LINOTYPE IMPROVEMENT SHEET

No. 305

DELIVERY LEVER BUSHING

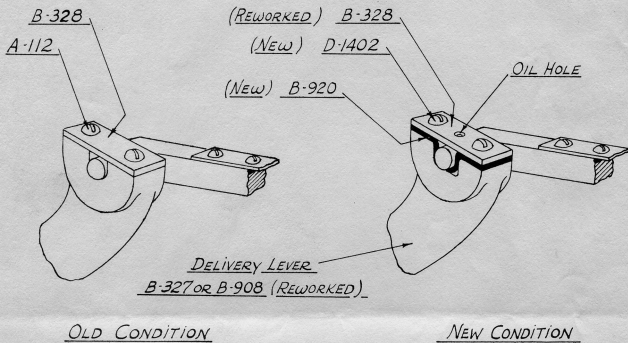
A Delivery Lever Bushing (B-920) has been added to the Delivery Lever to overcome difficulties caused by wear in the slot at top of Delivery Lever.

APPLIED IN FACTORY TO MODEL

All new Model 5-29-30-31-32-33-34-35-36 (30 Em) Machines.

Can be applied to all outstanding 30 Em Machines. See Mailing Sheet #601.
